# **REPORT ON WESTERN ROAD**

## REPORT ON WESTERN ROAD – TREE PROPOSALS

## Western Road

## **Opposite No. 231: SA Recommend Replacement**

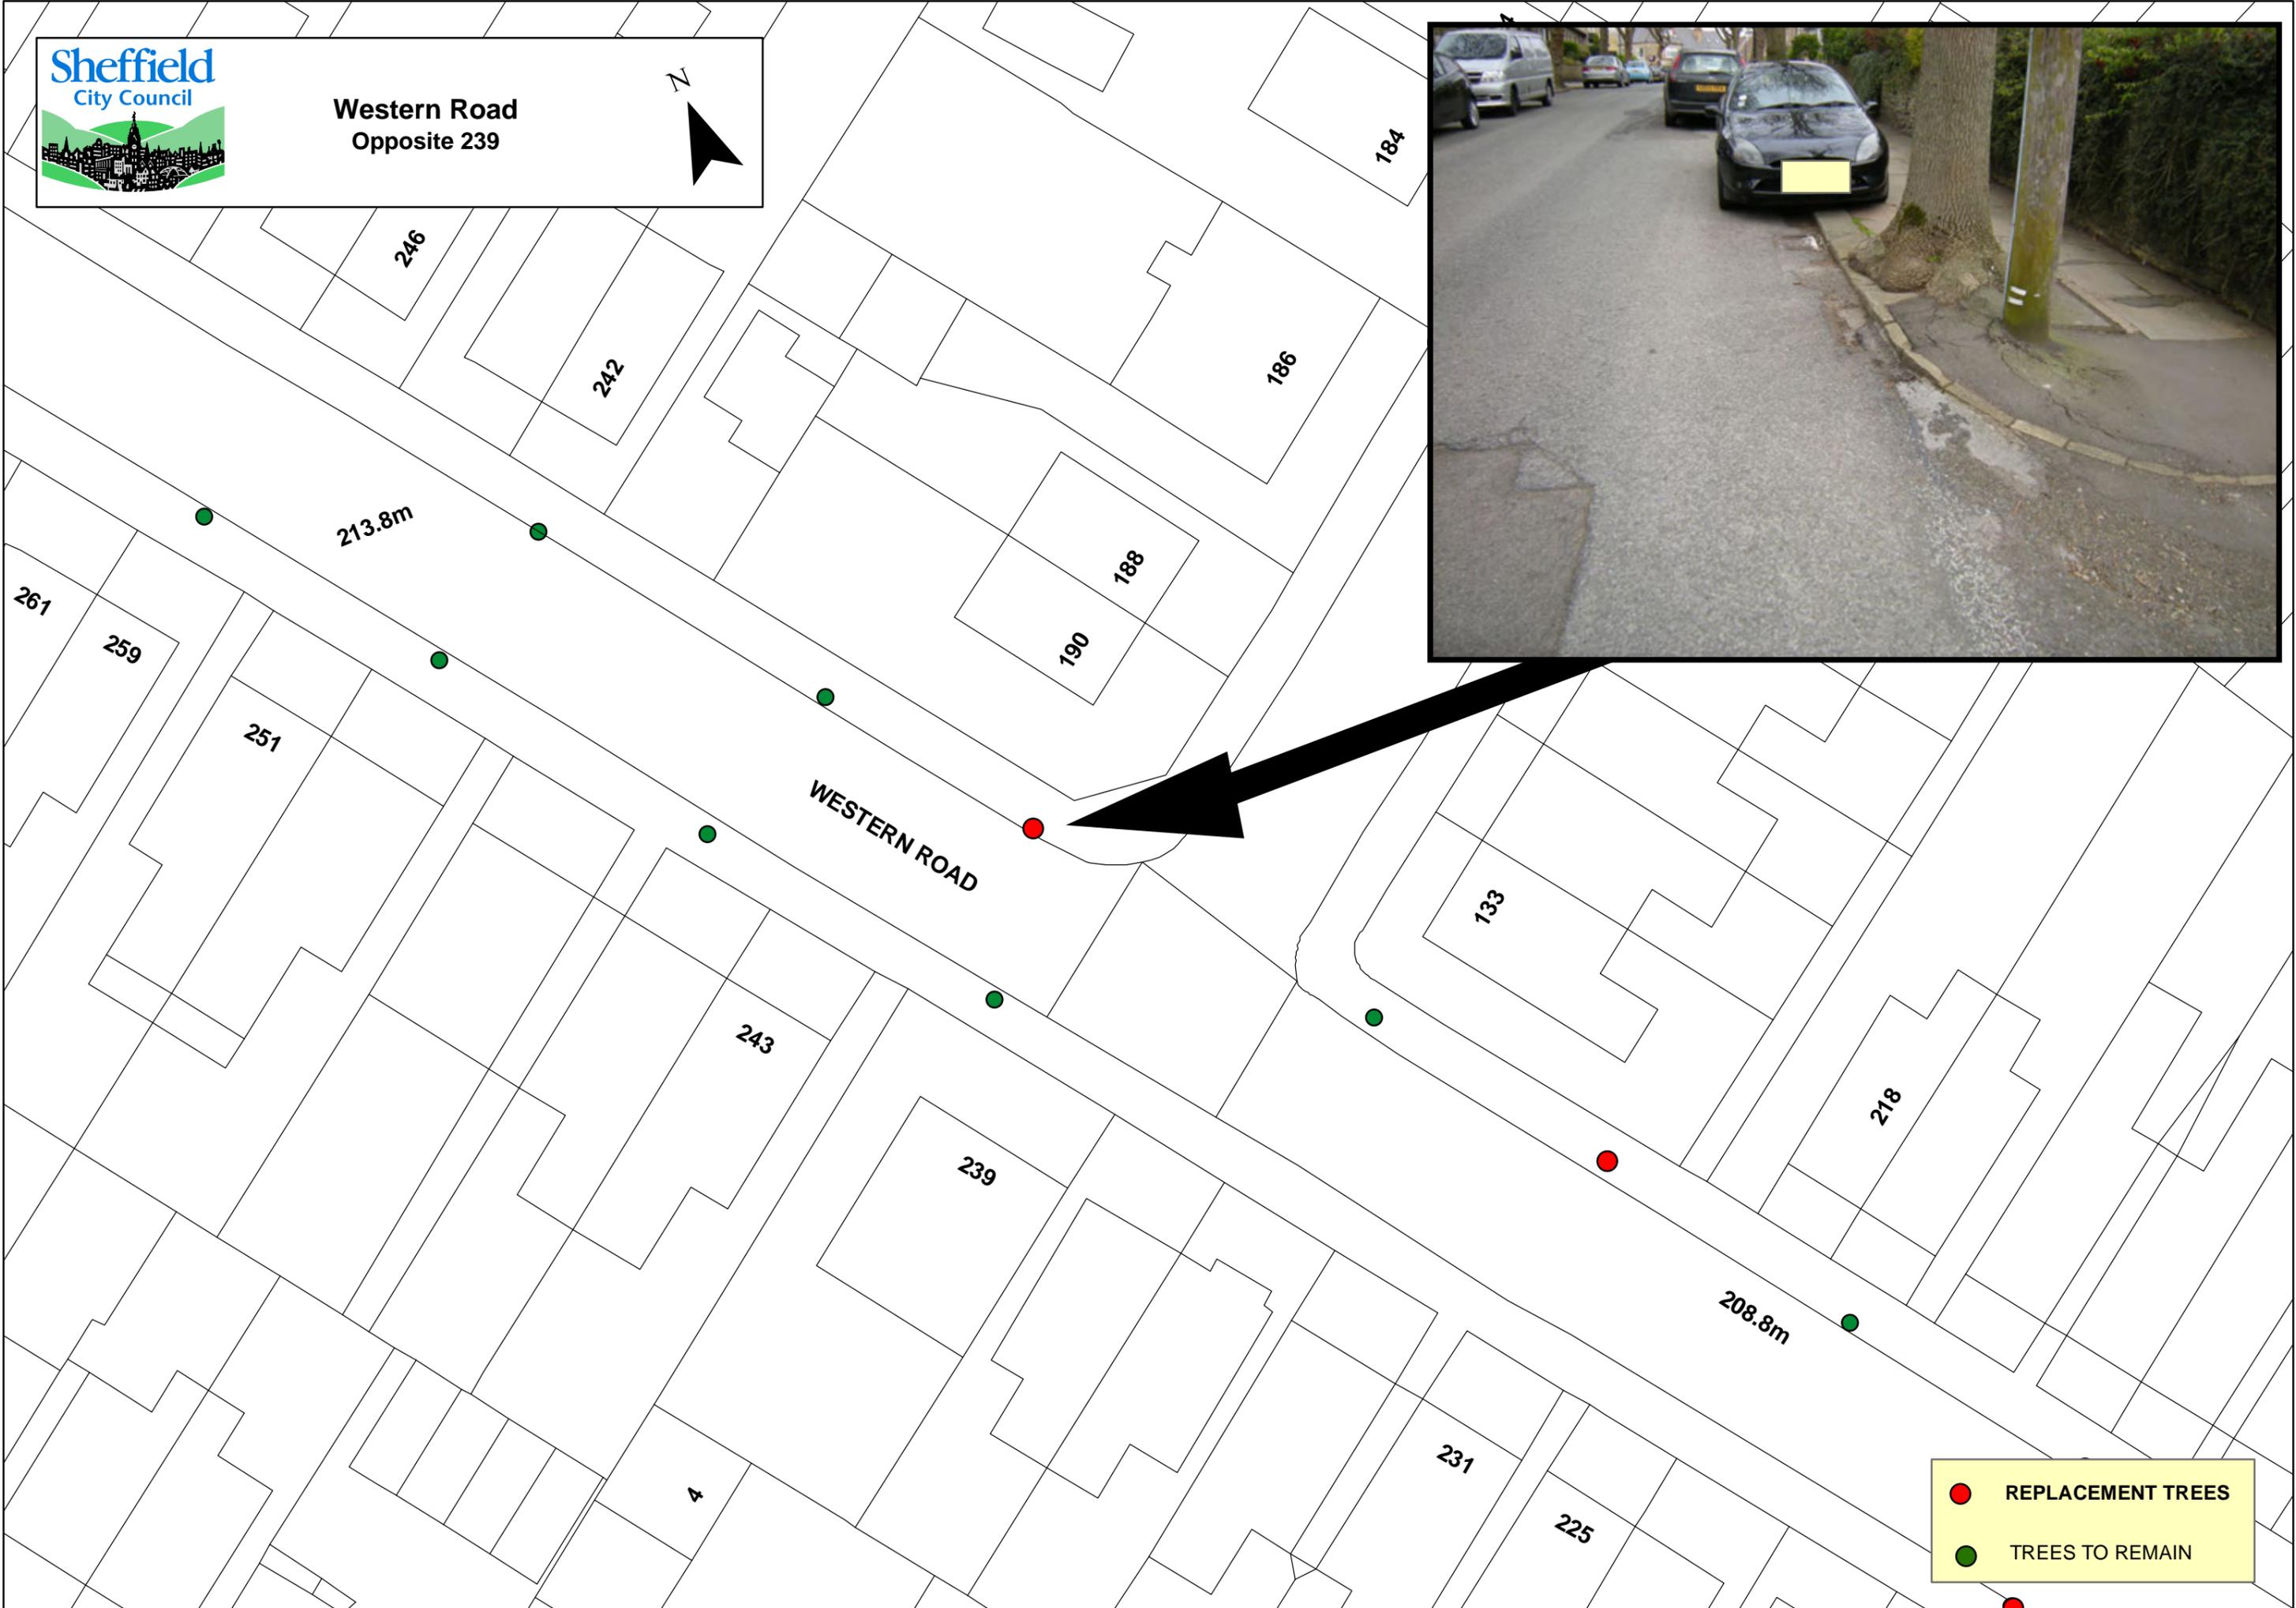
**Kerb displaced by buttress. Unable to reset or provide half kerb suggested by ITP. due to roots in kerblines. Roots tracing to and undermining third party wall, future damage is imminent.**

**Opposite No. 239: SA. Recommend Replacement: ITP in Agreement:**

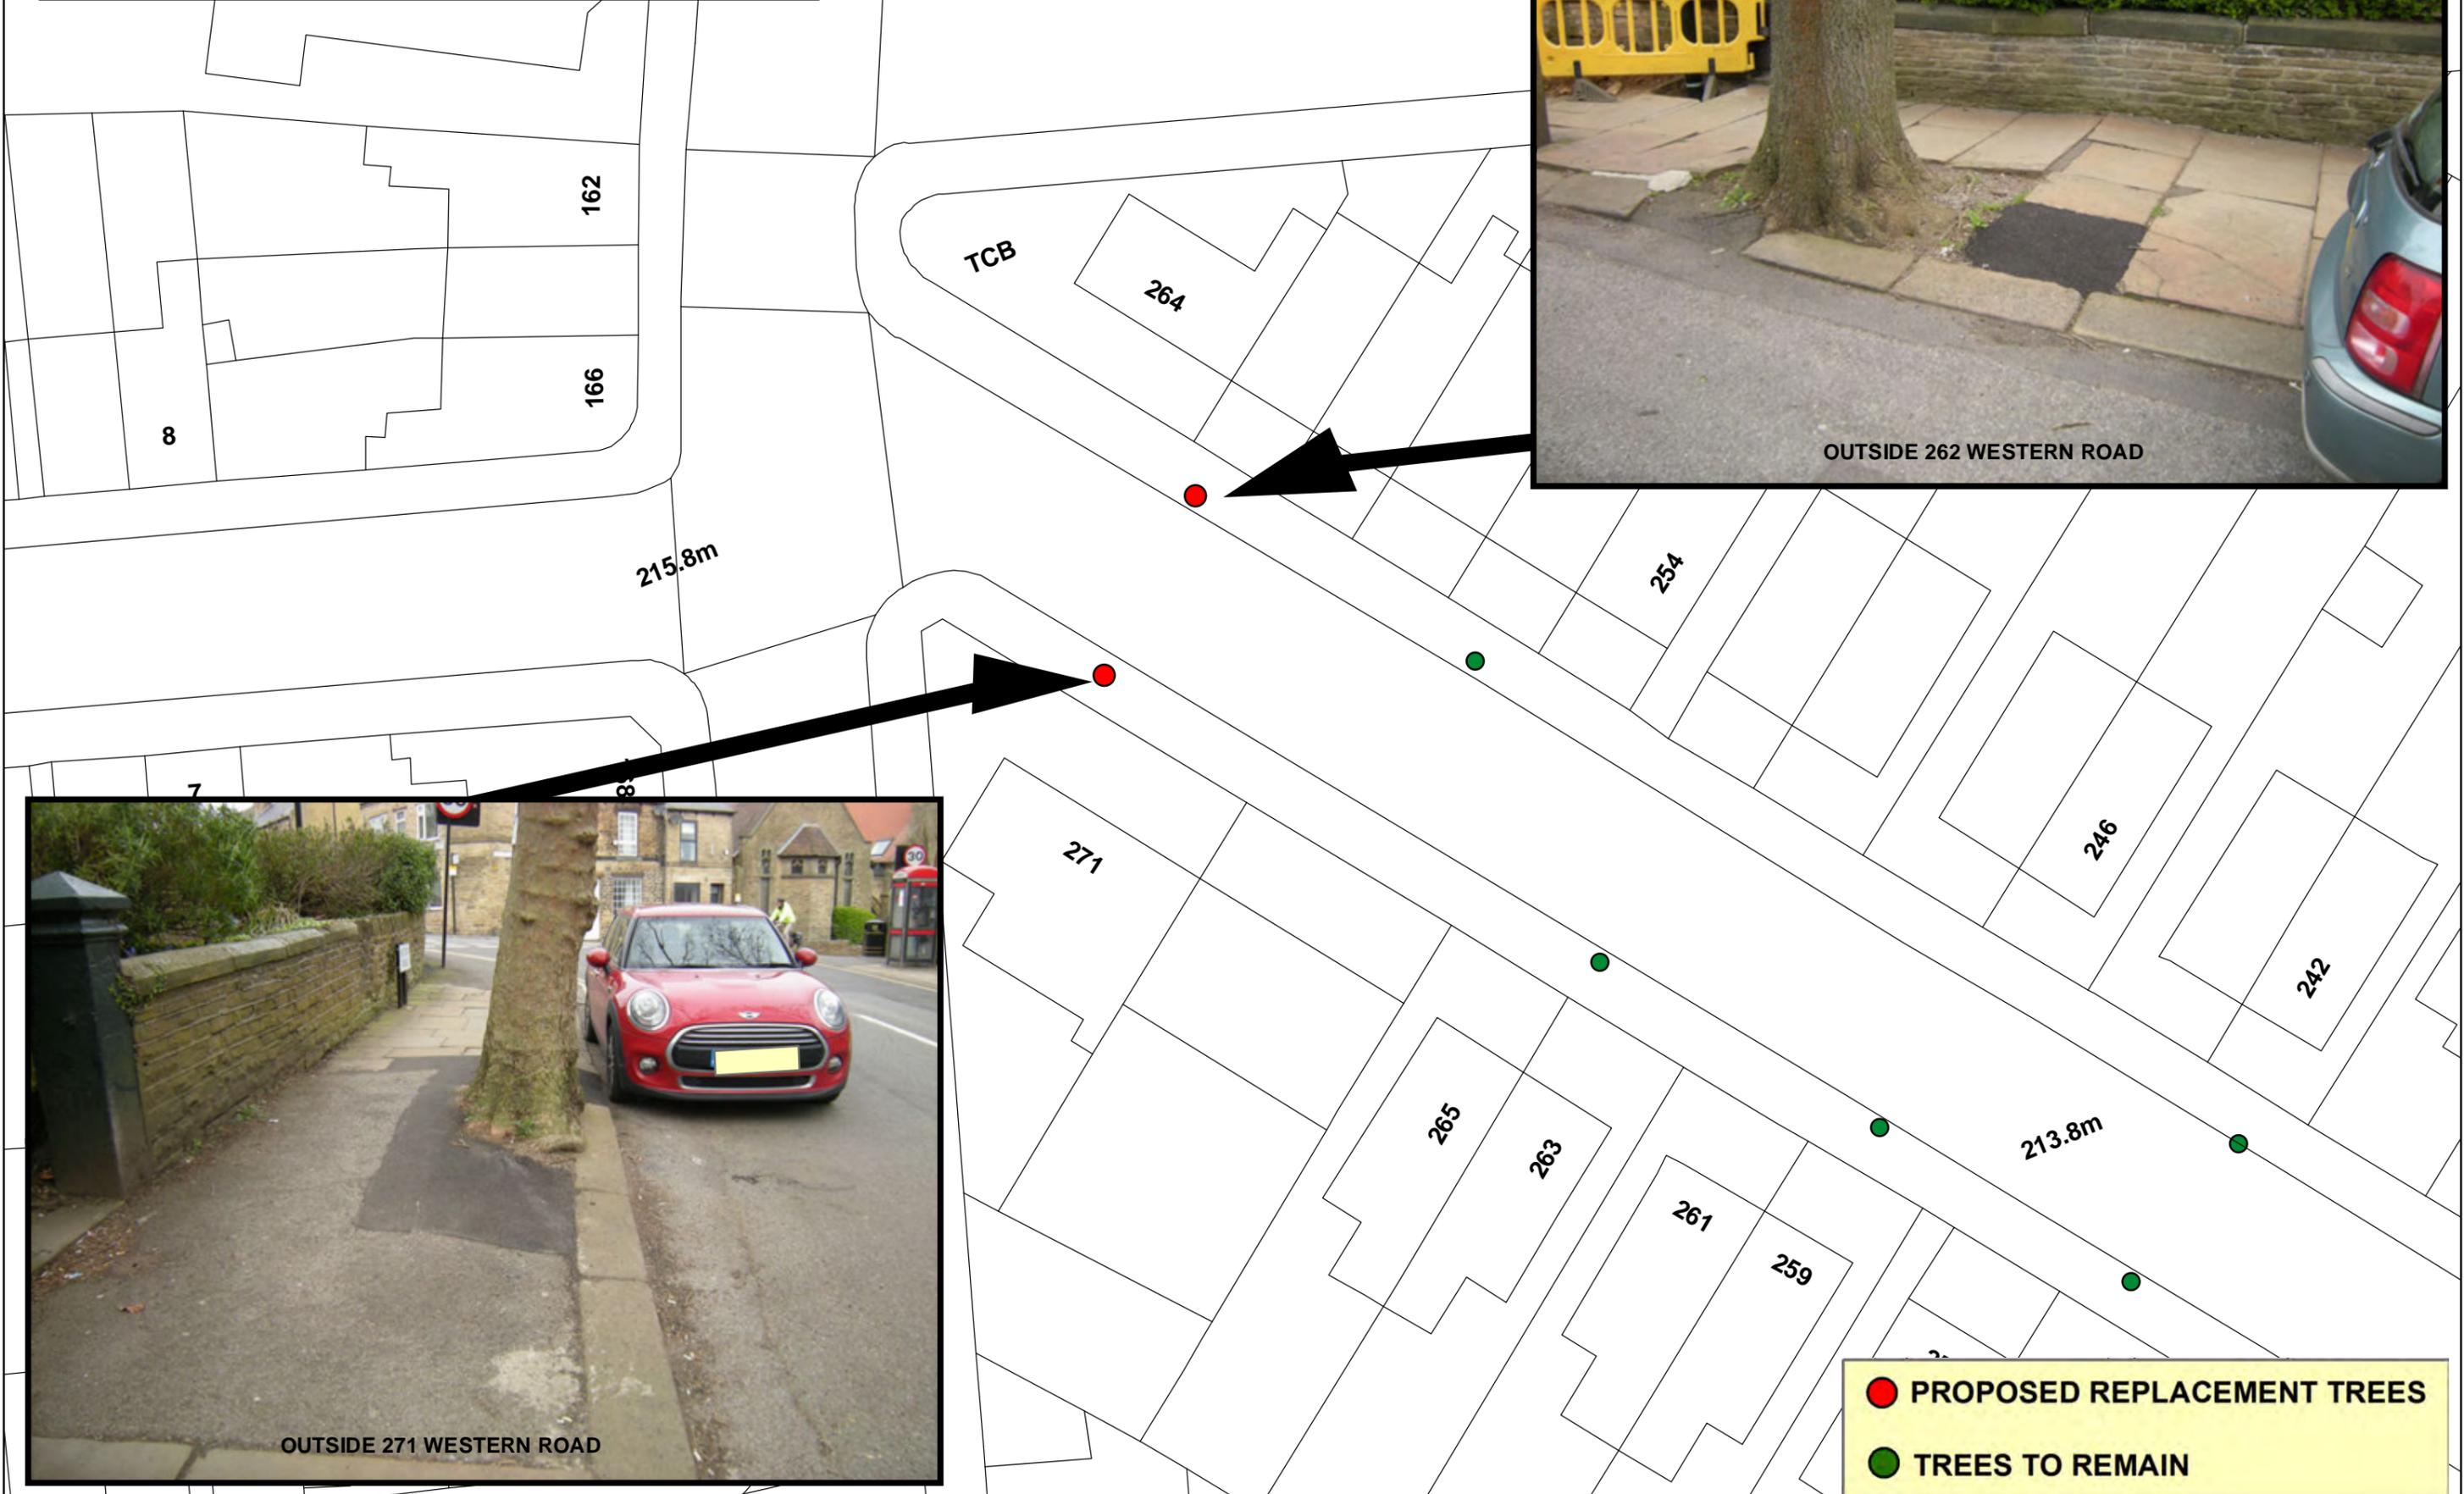
Buttress enveloping kerbs and preventing access to service cover. Unable to provide half kerb.
